Technical Report — Abnormal Tracker Operation Following the Side-Rivet Bearing Retrofit, Arctech SkyLine II

Plants: Angol · Falcon · Dinamo · Los Sauces I (PowerTree / Hergo / Infrastrutture portfolio)
Prepared by: iEnergia Group — Project Management & QA · Contractor entity: Visibility S.A.
Ref. IEN-ARC-BRG-001 · Rev. 05 · 21 August 2026 · Scope: tracker bearing system and tracker operation only

Figure 5 — sound analysis of the two recordings. Each vertical line is one impact. Left: 27-second recording, 48 impacts. Right: 10-second recording, 19 impacts; all activity ceases at ~8 s when the tracker stops.

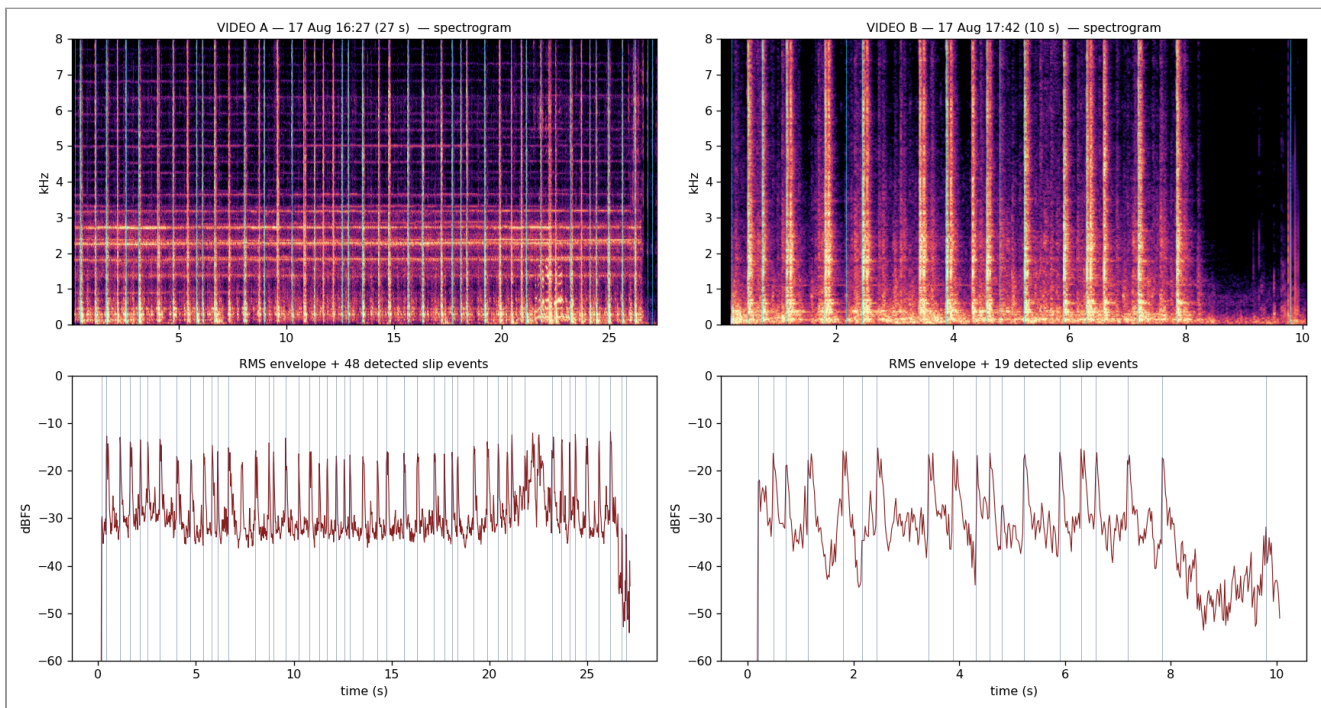
On 17 August 2026 we filmed the trackers in motion at two different bearing positions, 75 minutes apart. Analysis of the two soundtracks shows:

- a loud, sharp impact roughly **every half second** while the tracker moves — 48 impacts in the first recording (27 s), 19 in the second (10 s), at an almost constant rhythm in both;
- each impact followed by a brief metallic ringing of the structure; and
- in the second recording, the noise **stops completely the moment the tracker stops moving**.

Wind or background noise does not keep a steady rhythm, and does not switch off with the tracker. The recordings and the full analysis are annexed.
